# **Jordan Springs East Stage 3C**

## **Road Safety Audit - Concept Design**

JULY 2019

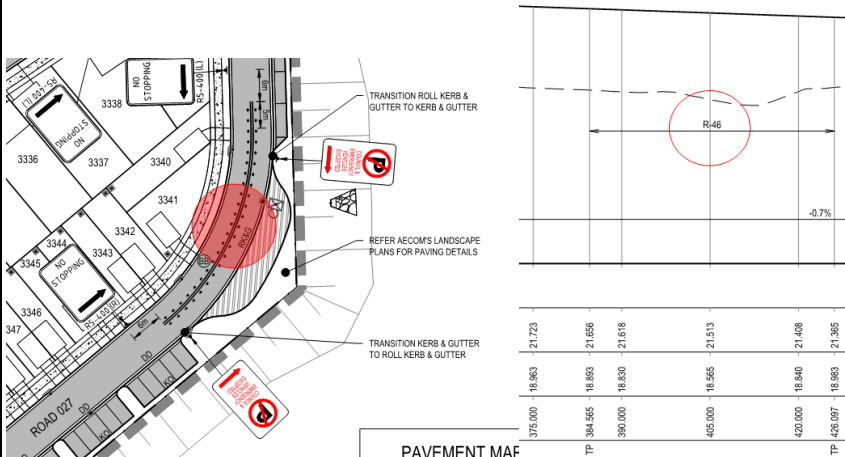
No.	Drawings/Location/ Road safety category	Description of findings	Risk rating (Frequency/ Severity)	Designer responses
1	CV-CARDNO-ST03C-1701 Road 027 Road Alignment	<p>Parking is permitted on the inside of the curve for northbound vehicles (on Road 027). A parked car in this area restricts the visibility of oncoming southbound traffic. This increases the likelihood of head on collisions due to northbound vehicles manouvring to avoid parked cars, turning into the path of oncoming traffic. This is compounded by the narrow road width (8 m) which would need to allow for parked cars and two way articulation.</p> 	Medium (Occasional/ Minor)	Noted – No parking signs to be provided.

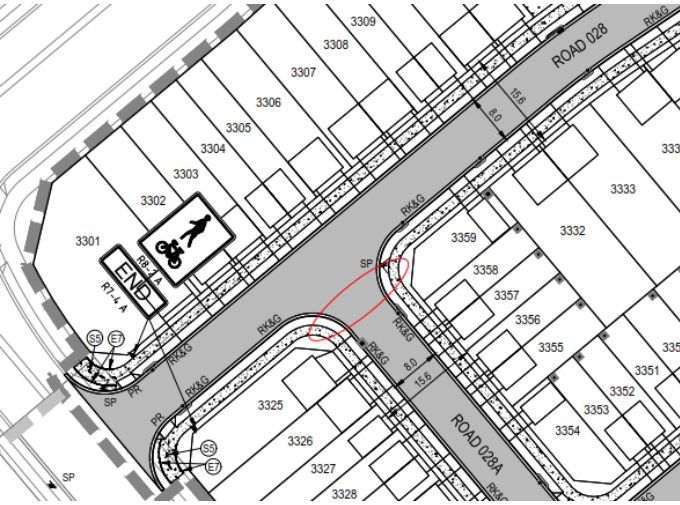
No.	Drawings/Location/ Road safety category	Description of findings	Risk rating (Frequency/ Severity)	Designer responses
2	CV-CARDNO-ST03C-1701 Road 027 Road Alignment	<p>Lot 3340 is located on the inside curve for northbound vehicles (on Road 027). This provides poor sight distance for egress increasing the likelihood of vehicle collisions. AS2890.1 CL3.2.4 requires 45 m sight distance for a 50 km/h design speed. Approximately 30 m is provided at this location without the sight envelop crossing future private property.</p> 	Medium (Occasional/ Minor)	<p>Horizontal curve radius in accordance with Penrith City Council design guidelines.</p> <p>No stopping signs to be provided as per Item No. 1.</p>

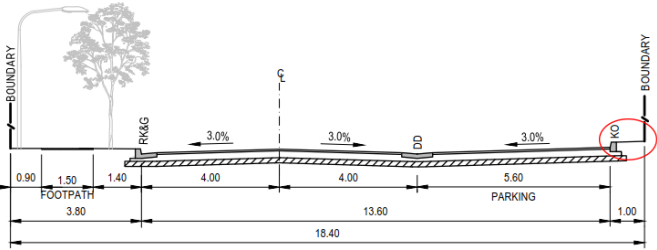
No.	Drawings/Location/ Road safety category	Description of findings	Risk rating (Frequency/ Severity)	Designer responses
4	CV-CARDNO-ST03C-1701  Corner of Roads 028A and 028  Pedestrian/cyclist infrastructure	Where Road 028A intersects with Road 028, no provision of pram ramp has been made. This would result in access difficulty for less abled people or even tripping over.  	Medium (Probable/ Limited)	Noted – Pedestrian crossing to be provided.

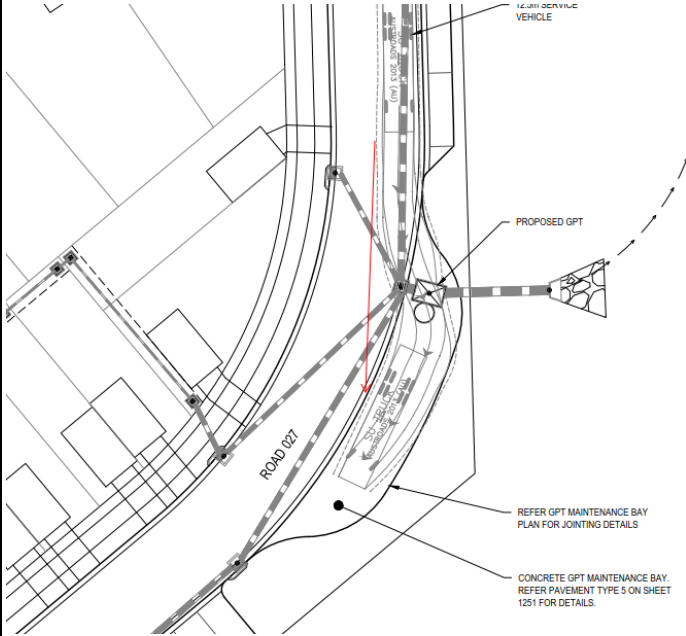
No.	Drawings/Location/ Road safety category	Description of findings	Risk rating (Frequency/ Severity)	Designer responses
6	CV-CARDNO-ST03C-1701 Road 027 Pedestrian/cyclist infrastructure	No allocation for disabled parking or pram ramps have been provided for on street parking provisions. This area is designated as Village centre which may make access for people with disabilities difficult. AS2890 CL4.5.1 states that a proportion of all parking should be allocated for people with disabilities.	Medium (Probable/ Limited)	Parking for people with disabilities is to be provided within stage 3D works.
7	CV-CARDNO-ST03C-1601 GPT maintenance access area Heavy vehicle infrastructure	<p>The GPT maintenance bay is located at the road curve where driver's sight line to the approaching traffic from the north may be limited. This could result in vehicular collisions involving service vehicles.</p> 	Medium (Occasional/ Minor)	Drivers sights lines are unobstructed.

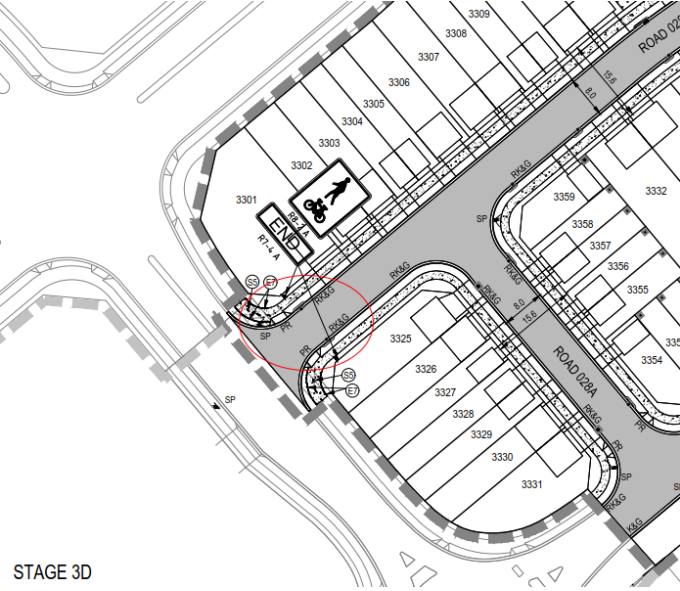
No.	Drawings/Location/ Road safety category	Description of findings	Risk rating (Frequency/ Severity)	Designer responses
8	CV-CARDNO-ST03C-1701  The southern end of Road 028  Pedestrian/cyclist infrastructure	<p>There is no signposting to indicate the start of the shared path, facing north. Pedestrians along the footpaths of Road 028 who are not aware of the cyclists' presence, may not be able to safely transition onto the shared path. This could lead to cyclists colliding with pedestrians.</p>  <p>STAGE 3D</p>	Medium (Occasional/ Minor)	Noted – Signage to be added.
